## Amendments agreed to ECE/TRANS/WP.29/GRSP/2010/37 during the 48th session of GRSP

### Proposal for Amendment 2

“Figure 13

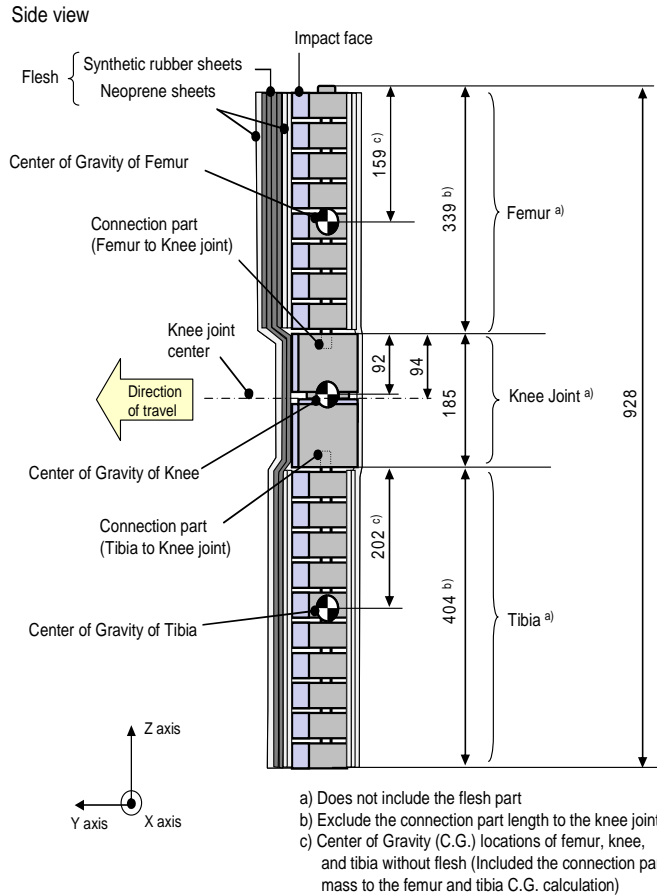
The lower legform impactor shall consist of flesh, flexible long bone segments (representing femur and tibia), and a knee joint as shown in Figure 13.

The overall length of the impactor shall be  $928 \pm 3$  mm, having a required mass of  $13.2 \pm 0.7$  kg including flesh. The length of the femur, knee joint, and tibia shall be  $339 \pm 2$  mm,  $185 \pm 1$  mm, and  $404 \pm 2$  mm respectively. The knee joint centre position shall be  $94 \pm 1$  mm from the top of the knee joint.

Insert new Figures 13 to 17., to read:

Figure 14  
**FlexPLI; femur, tibia, and knee dimensions (Top view)**

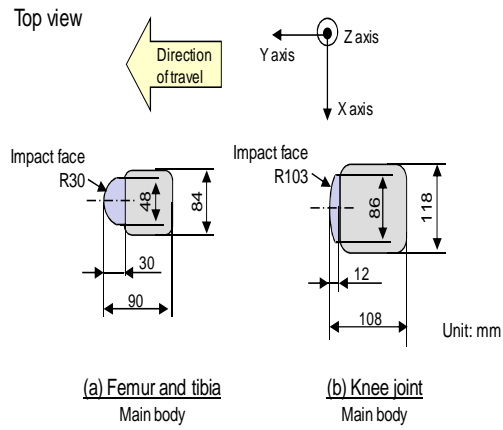
6.3.1.2.1. The cross-sectional shape perpendicular to the Z axis of the femur and tibia main bodies shall be  $90 \pm 2$  mm in width along the Y axis, and  $84 \pm 1$  mm in width along the X axis as shown in Figure 14 (a). The impact face shall be  $30 \pm 1$  mm in radius,  $30 \pm 1$  mm in width along the Y axis, and  $48 \pm 1$  mm in width along the X axis as shown in Figure 14 (a).

6.3.1.2.2. The cross-sectional shape perpendicular to the Z axis of the knee joint shall be  $108 \pm 2$  mm in width along the Y axis, and  $118 \pm 1$  mm in width along the X axis as shown in Figure 14 (b). The impact face shall be  $103 \pm 1$  mm in radius,  $12 \pm 1$  mm in width along the Y axis, and  $86 \pm 1$  mm in width along the X axis as shown in Figure 14 (b).

Figure 15  
**FlexPLI; flesh dimensions**

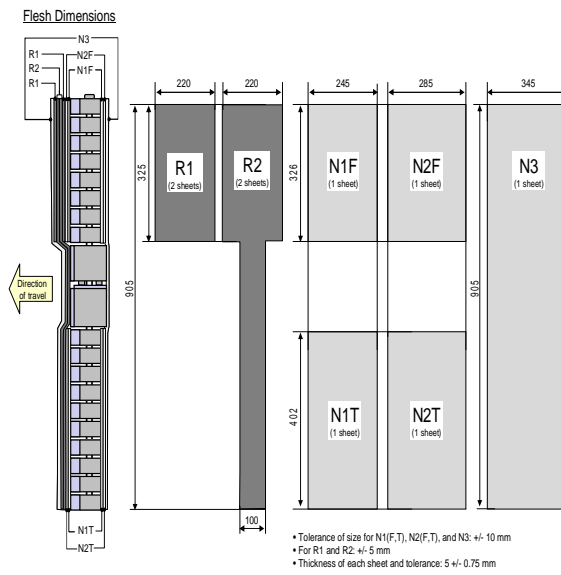
6.3.1.2.4. For each test, the impactor (femur, knee joint, and tibia) shall be covered by flesh composed of synthetic rubber sheets (R1, R2) and neoprene

sheets (N1F, N2F, N1T, N2T, N3) as shown in Figure 15. The sheets are required to have a compression characteristic as shown in Figure 16. The compression characteristic shall be checked using the same batch of sheets as those used for the impactor flesh. The size of the sheets shall be within the requirements described in Figure 16.

Figure 17  
**FlexPLI; instrument locations**

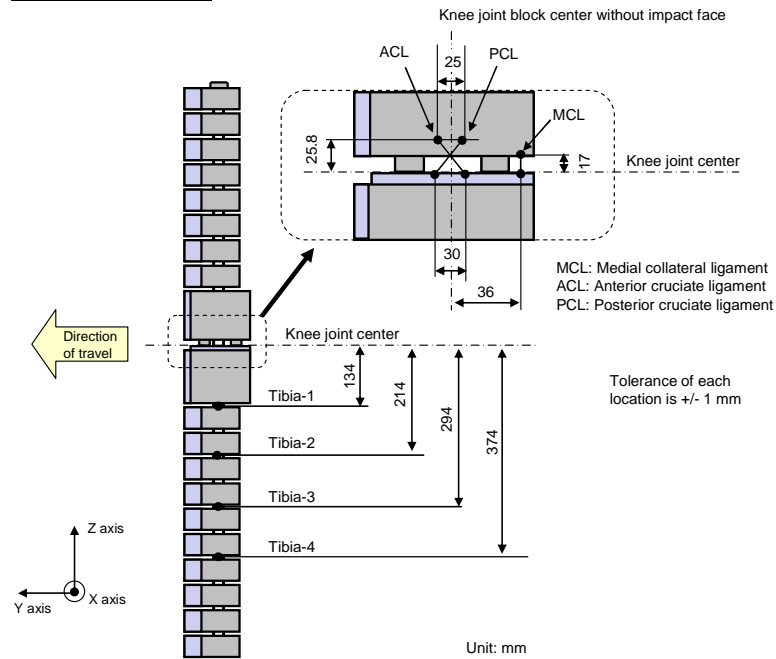
6.3.1.2.6.1. Four transducers shall be installed in the tibia to measure bending moments applied to the tibia. The sensing locations of each of the transducers are as follows: tibia-1:  $134 \pm 1$  mm, tibia-2:  $214 \pm 1$  mm, tibia-3:  $294 \pm 1$  mm and tibia-4:  $374 \pm 1$  mm below the knee joint centre respectively as shown in Figure 17. The measurement axis of each transducer shall be the X axis of the impactor.

6.3.1.2.6.2. Three transducers shall be installed in the knee joint to measure elongations of the medial collateral ligament (MCL), anterior cruciate ligament (ACL), and posterior cruciate ligament (PCL). The measurement locations of each transducer are shown in Figure 17. The measurement locations shall be within  $\pm 3$  mm along the X axis from the knee joint centre.

“Figure 23

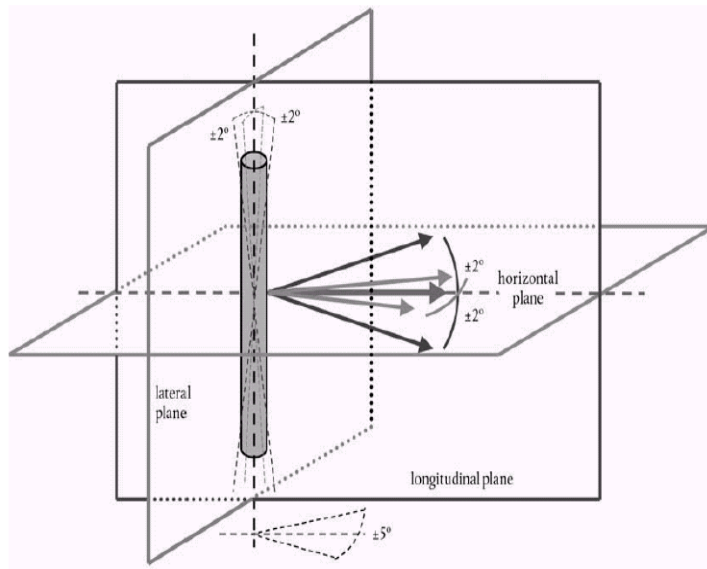
7.1.2.2. **The direction of the impact velocity vector shall be in the horizontal plane and parallel to the longitudinal vertical plane of the vehicle. The tolerance for the direction of the velocity vector in the horizontal plane and in the longitudinal plane shall be  $\pm 2^\circ$  at the time of first contact. The axis of the impactor shall be perpendicular to the horizontal plane, with a roll and pitch angle tolerance of  $\pm 2^\circ$  in the lateral and longitudinal plane. The horizontal, longitudinal and lateral planes are orthogonal to each other (see Figure 23).**

- 7.1.2.3.2. At the time of first contact the impactor shall have the intended orientation about its vertical axis, for the correct operation of its knee joint, with a yaw angle tolerance of  $\pm 5^\circ$  (see Figure 23).
- 7.1.2.3.3. At the time of first contact the centre line of the impactor shall be within a  $\pm 10$  mm tolerance to the selected impact location.
- 7.1.2.3.4. During contact between the impactor and the vehicle, the impactor shall not contact the ground or any object which is not part of the vehicle.
- 7.1.2.4. The impact velocity of the impactor when striking the bumper shall be  $11.1 \pm 0.2$  m/s. The effect of gravity shall be taken into account when the impact velocity is obtained from measurements taken before the time of first contact.”

**FlexPLI to bumper tests for complete vehicle in normal ride attitude (left) and for cut-body mounted on supports (right) (see paragraph 7.1.2.3.)**

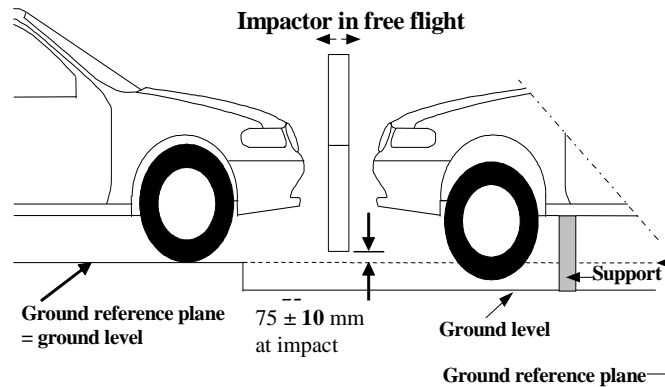
7.1.2.3. **The bottom of the impactor shall be at 75 mm above ground reference plane at the time of first contact with the bumper (see Figure 24), with a  $\pm 10$  mm tolerance. When setting the height of the propulsion system, an allowance must be made for the influence of gravity during the period of free flight of the impactor.**

“Figure 31  
Requirement corridor of femur and tibia in static certification test (see paragraph 8.2.1.2.)

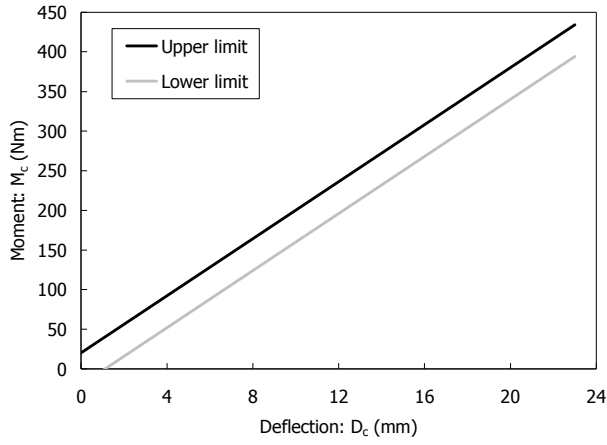
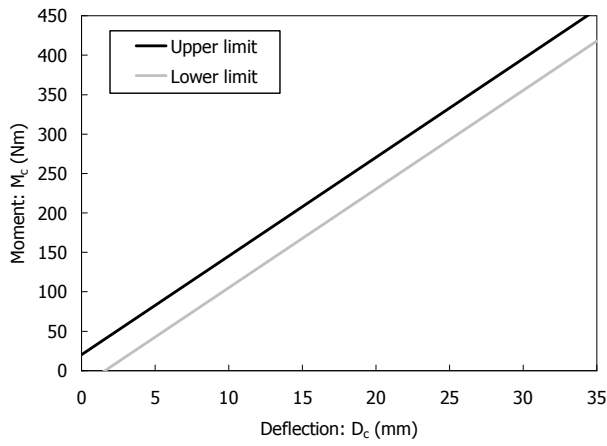
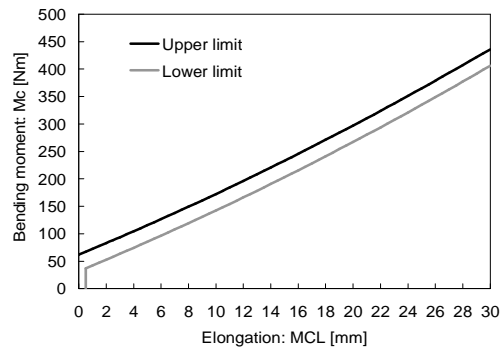
**8.2.1.2.** When the femur and tibia of the impactor are loaded in bending in accordance with paragraph 8.2.1.4., the applied moment and generated deflection at the centre of the femur and tibia ( $M_c$  and  $D_c$ ) shall be within the corridors shown in Figure 31.

**Requirement corridors for knee joint in static certification test (see paragraph 8.2.1.3.)**

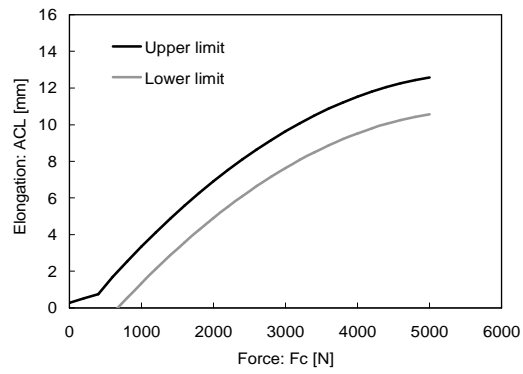
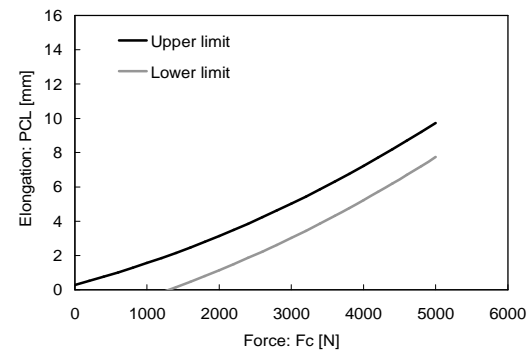
**8.2.1.3.** When the knee joint of the impactor is loaded in bending in accordance with paragraph 8.2.1.5., the MCL, ACL, and PCL elongations and applied bending moment or force at the centre of the knee joint ( $M_c$  or  $F_c$ ) shall be within the corridors shown in Figure 32.

Figure 33  
**Test set-up for femur in static certification tests (see paragraph 8.2.1.4.)**

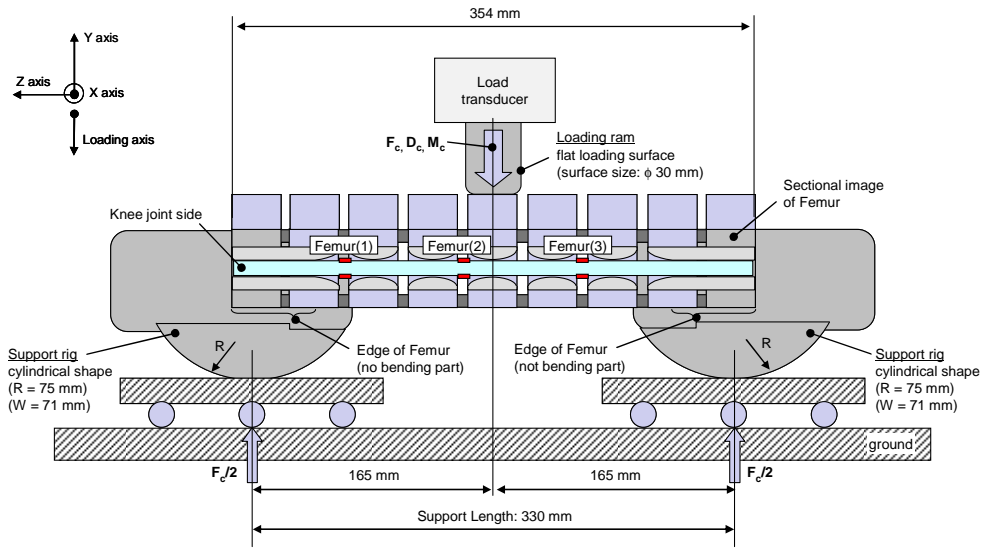
**8.2.1.4.** The edges of the femur and tibia, not bending parts, shall be mounted to the support rig firmly as shown in Figure 33 and Figure 34. The Y axis of the impactor shall be parallel to the loading axis within  $180 \pm 2^{\circ}$  tolerance. In order to avoid friction errors, roller plates shall be set underneath the support rigs.

The centre of the loading force shall be applied at the centre of the femur and tibia within  $\pm 2^{\circ}$  tolerance along the Z axis. The force shall be increased at a rate between 10 and 100 mm/minute until the bending moment at the centre part ( $M_c$ ) of the femur or tibia reaches 400 Nm.

Figure 35  
**Test set-up for knee joint in static certification test (see paragraph 8.2.1.5.)**

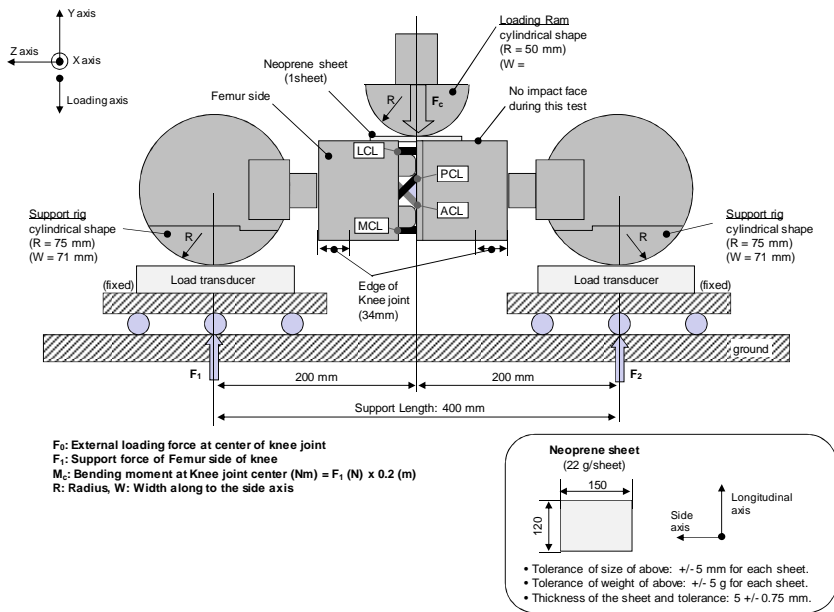
**8.2.1.5.** The edges of the knee joint, not bending parts, shall be mounted to the support rig firmly as shown in Figure 35. The Y axis of the impactor shall be parallel to the loading axis within  $180 \pm 2^{\circ}$ . In order to avoid friction errors, roller plates shall be set underneath the support rigs. To avoid impactor damage, a neoprene sheet shall be set underneath the loading ram and the impactor face of the knee joint which is described in the Figure 14 shall be removed. The neoprene sheet used in this test shall have compression characteristics as shown in Figure 16.

The centre of the loading force shall be applied at the centre of the knee joint within  $\pm 2^{\circ}$  tolerance along the Z axis. The external load shall be

increased at a rate between 10 and 100 mm/minute until the bending moment at the centre part of the knee joint ( $M_c$ ) reaches 300 Nm.

Figure 36  
**Test set-up for dynamic lower legform impactor certification test, pendulum type (see paragraph 8.2.2.4.)**

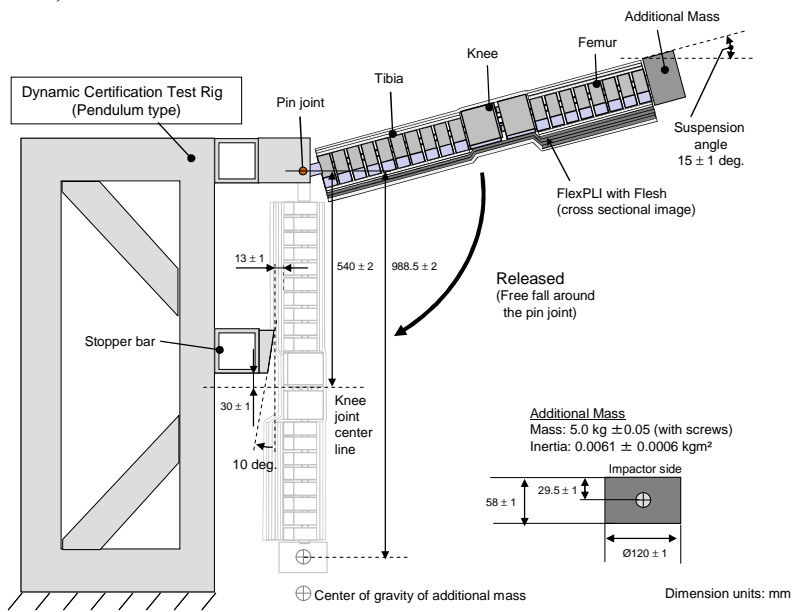
**8.2.2.4.1.** The impactor, including flesh, shall be suspended from the dynamic certification test rig  $15 \pm 1^\circ$  upward from the horizontal as shown in Figure 36. The impactor shall be released from the suspended position, whereupon the impactor falls freely against the pin joint of the test rig as shown in Figure 36.

**8.2.2.4.2.** The knee joint centre of the impactor shall be  $30 \pm 1$  mm below the bottom line of the stopper bar, and the tibia impact face shall be located  $13 \pm 1$  mm from the front upper edge of the stopper bar when the stopper block is removed from the stopper bar and then hung from the impactor without any contact (see Figure 36).

Figure 37  
**Test set-up for dynamic lower legform impactor certification test, inverse type (see paragraph 8.2.3.4.)**

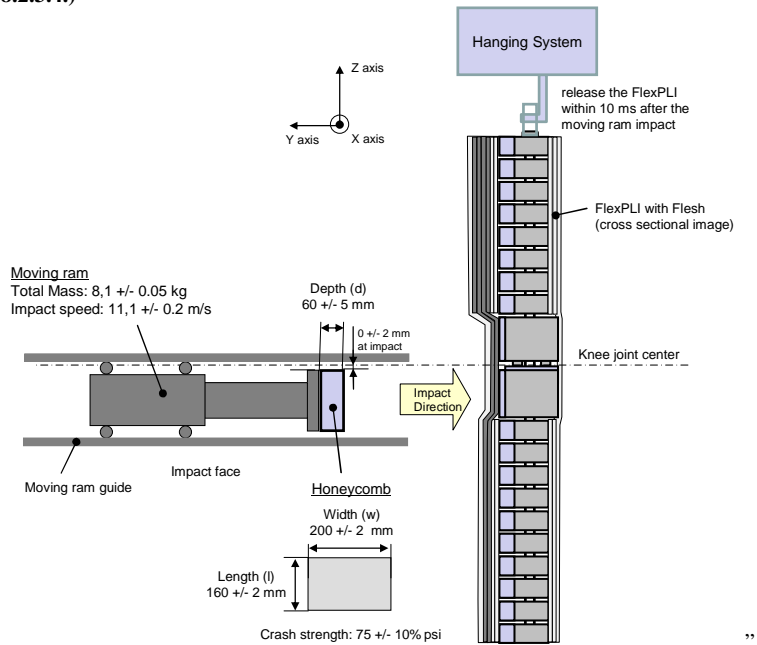
8.2.3.4.1. The fully assembled FlexPLI (with flesh and skin) shall be stationary suspended vertically from a test rig as shown in Figure 37. It is then impacted by the upper edge of a linearly guided Al honeycomb impactor, covered by a thin (less than 1 mm thickness) paper cloth, at an impact speed of  $11,1 \pm 0,2$  m/s. The legform is to be released from the test rig within 10 ms after the time of first contact to ensure a free flight condition.

8.2.3.4.2. The honeycomb of 5052 alloy, which is attached in front of the moving ram, shall have a crush strength of  $75 \pm 10$  per cent psi and dimensions of  $l = 200 \pm 2$  mm,  $w = 160 \pm 2$  mm and  $d = 60 \pm 5$  mm. To ensure a consistent and good level of repeatability, the honeycomb should either have a 3/16 inch cell size in combination with a density of 3.1 pcf or a 1/4 inch cell size in combination with a density of 2.3 pcf or a 3/16 inch cell size in combination with a density of 2.0 pcf.

8.2.3.4.3. The upper edge of the honeycomb face is to be in line with the rigid plate of the linearly guided impactor. At time of first contact, the upper edge of the honeycomb is to be in line with the knee joint centre line within a vertical tolerance of  $0 \pm 2$  mm. The honeycomb shall not be deformed before the impact test.
